7019 EASTERN AVE. 2010  
TAKOMA PARK

SUBJECT: Historic Area Work Permit #544092—rear addition and alterations

**MONTGOMERY COUNTY HISTORIC PRESERVATION COMMISSION**  
**STAFF REPORT**

<b>Address:</b>	7019 Eastern Avenue, Takoma Park	<b>Meeting Date:</b>	9/22/10
<b>Applicant:</b>	Sabrina Eaton (Rick Vitullo, Architect)	<b>Report Date:</b>	9/15/10
<b>Resource:</b>	Contributing Resource Takoma Park Historic District	<b>Public Notice:</b>	9/8/10
<b>Review:</b>	HAWP	<b>Tax Credit:</b>	None
<b>Case Number:</b>	37/3-10AAA	<b>Staff:</b>	Anne Fothergill
<b>PROPOSAL:</b> Rear addition

Eaton/Rodgers Residence  
7019 Eastern Ave.  
Takoma Park, MD 20912  
1" = 20'-0"

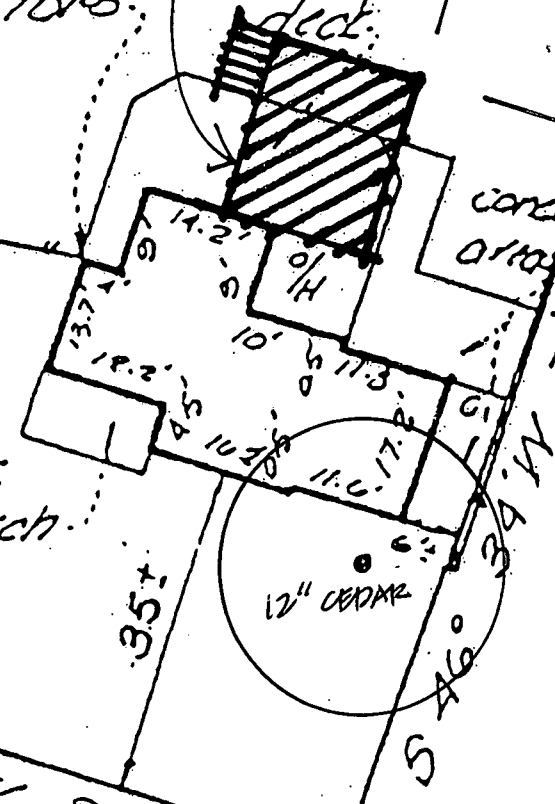
The HPC recently approved an addition and fencing for this property in Takoma Park and the applicants would like to make some minor changes to the HAWP. Attached are a site plan showing the location of the proposed fencing changes and some photos of existing conditions. An excerpt from their email is below. Also, if you are curious, in one of the photos (816) you can see the rear addition under construction.

SECOND FLOOR PLAN  
1/4" = 1'-0"

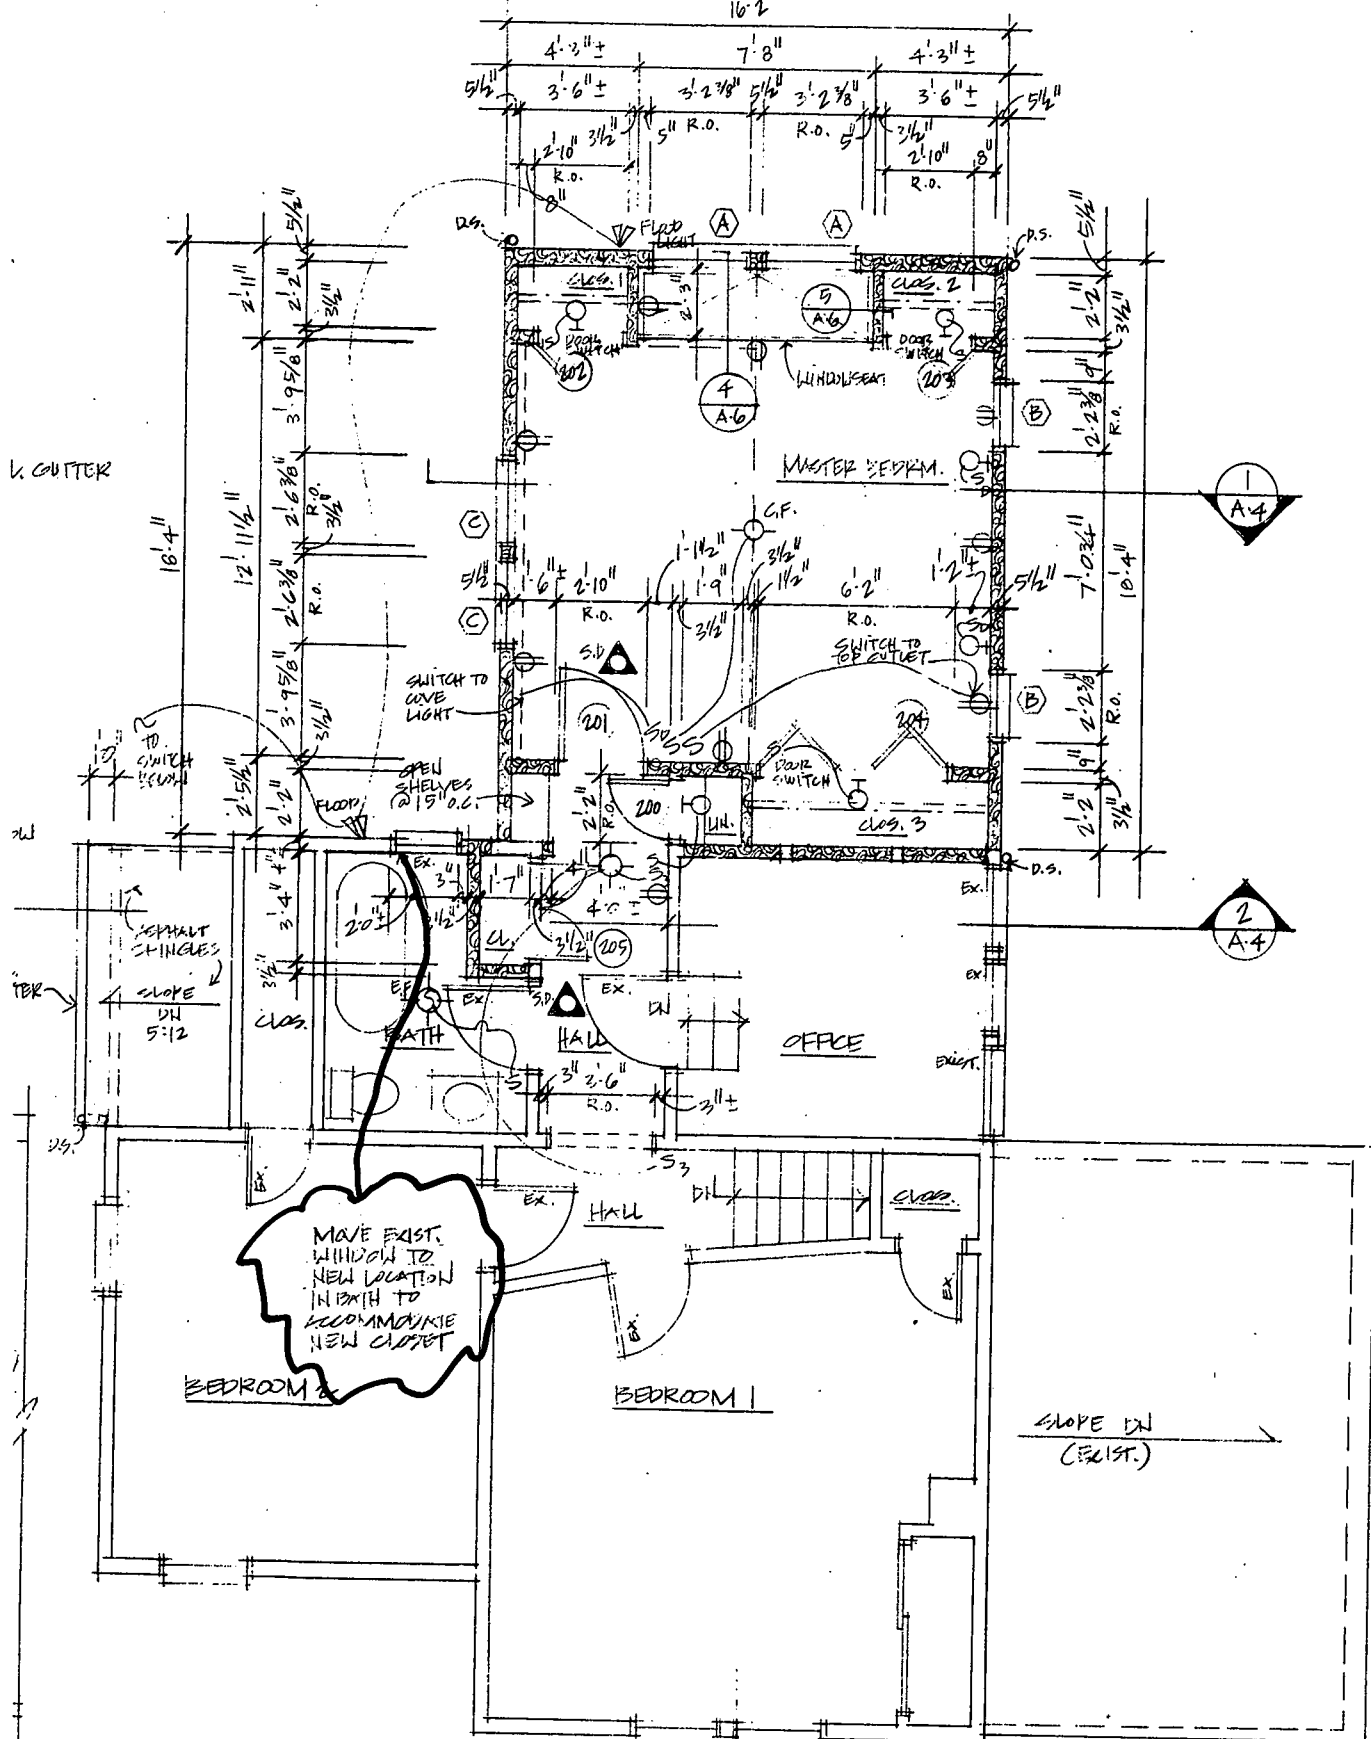
MOVE EXIST. WINDOW TO NEW LOCATION IN BATH TO ACCOMMODATE NEW CLOSET

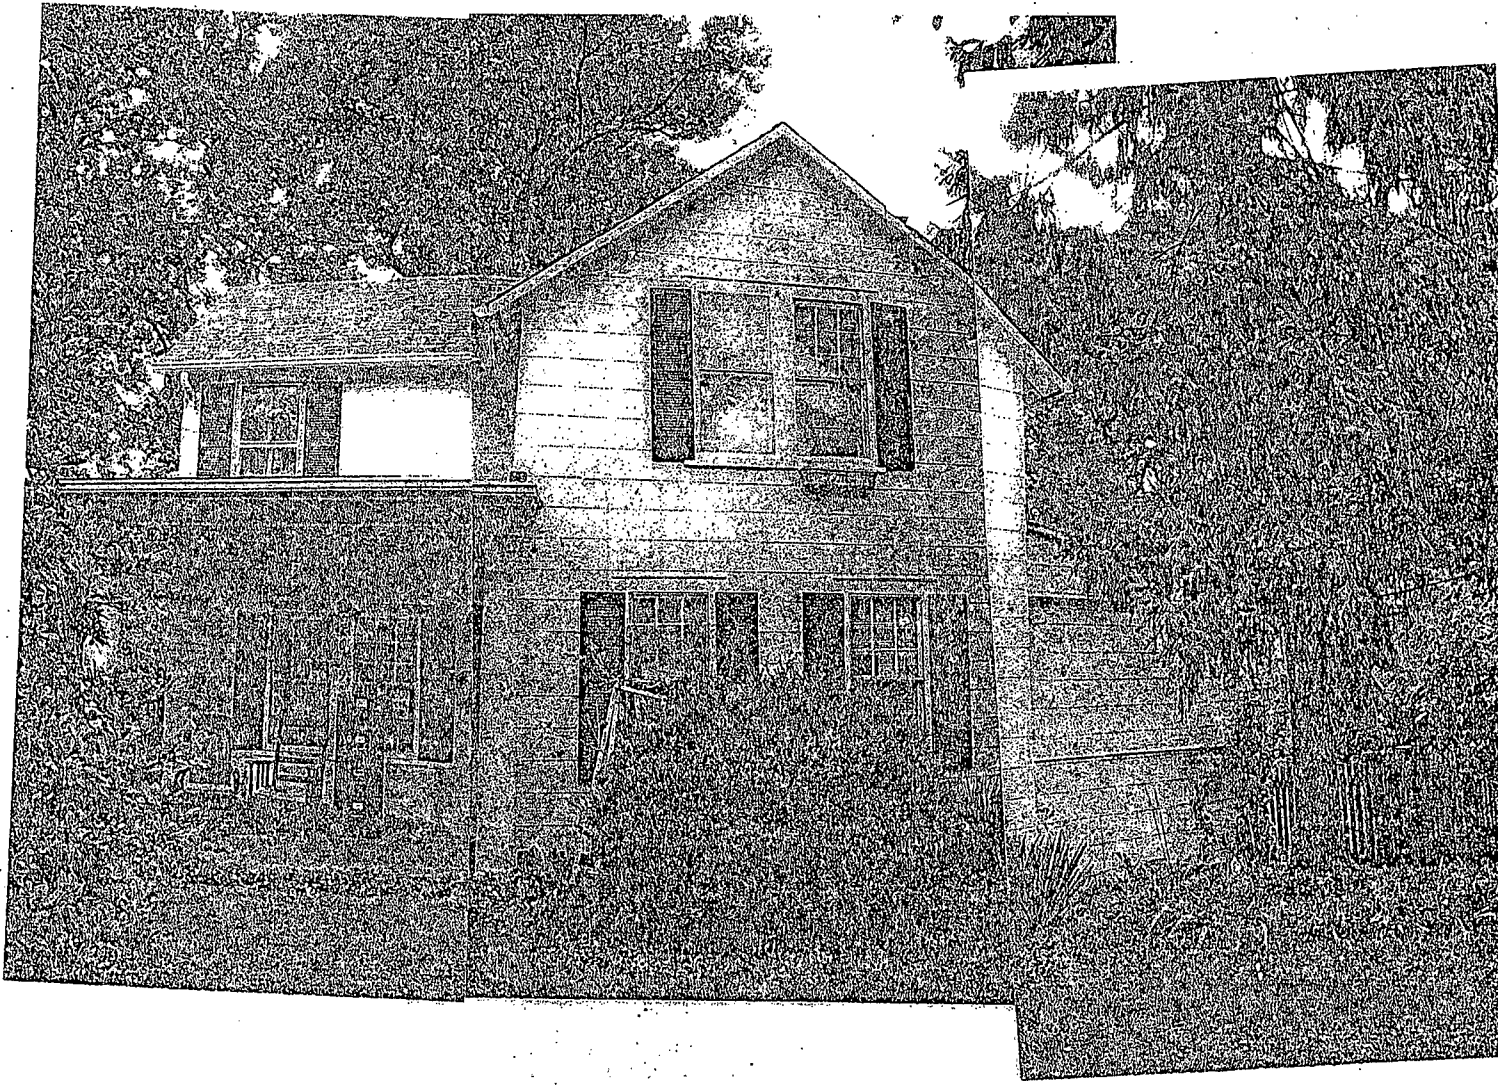
MR. JESTER: And just one other comment, kind of more practically about the massing proposed. I think the shed addition on, I guess it's connected. If you look at the, I guess it's the right side elevation, you've got a considerable number of roof areas that are coming down to basically one gutter.

And I think just looking at the plan, I think you need to look at that a little more carefully to make sure that all those areas can be kind of handled in a way that's not going to result in leaks in the building going forward. But that's just a, you know, it's something you need to look at. Does that give you some good direction to --
